**Proposal for Supplement 5 to the 07 series of amendments and
for Supplement 1 to 08 series of amendments to UN
Regulation No. 16 (Safety-belts)**

**Submitted by the expert from the International Organization of Motor
Vehicle Manufacturers**

Frontal impact, curve of trolley's deceleration or acceleration, as function of time

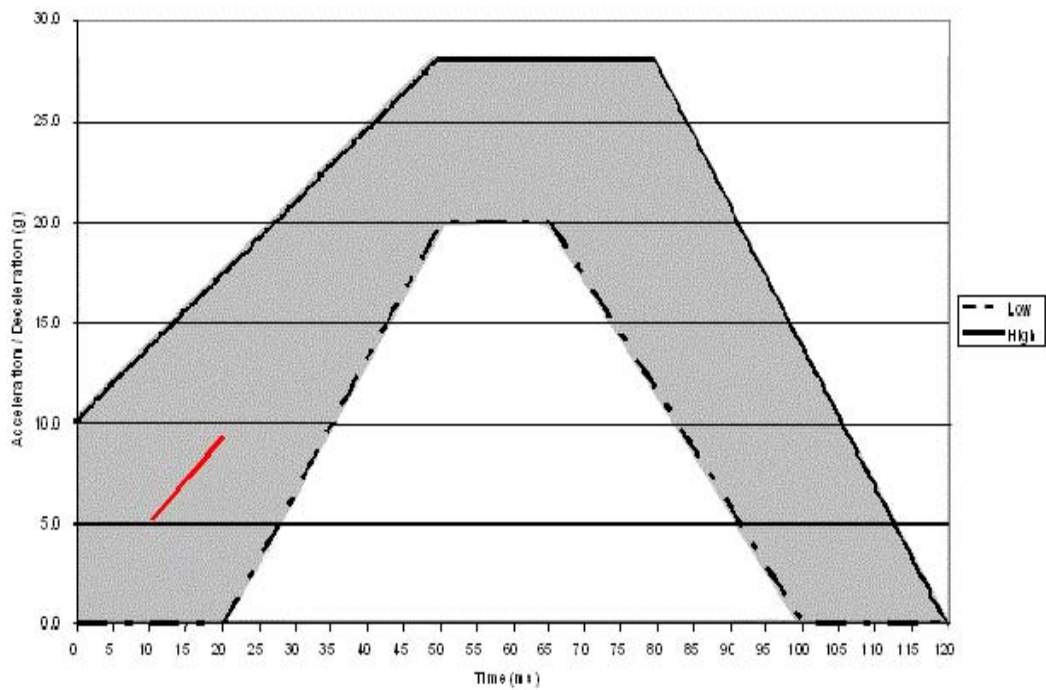
Insert new Annex 19, to read:

"Annex 19

Description of curve of trolley's deceleration or acceleration and test devices (CRS)

<i>Definition of the different curves</i>		
<i>Time (ms)</i>	<i>Acceleration (g) Low corridor</i>	<i>Acceleration (g) High corridor</i>
0	-	10
20	0	-
50	20	28
65	20	-
+80	-	28
100	0	-
120	0	-

The additional segment applies only for the acceleration sled.
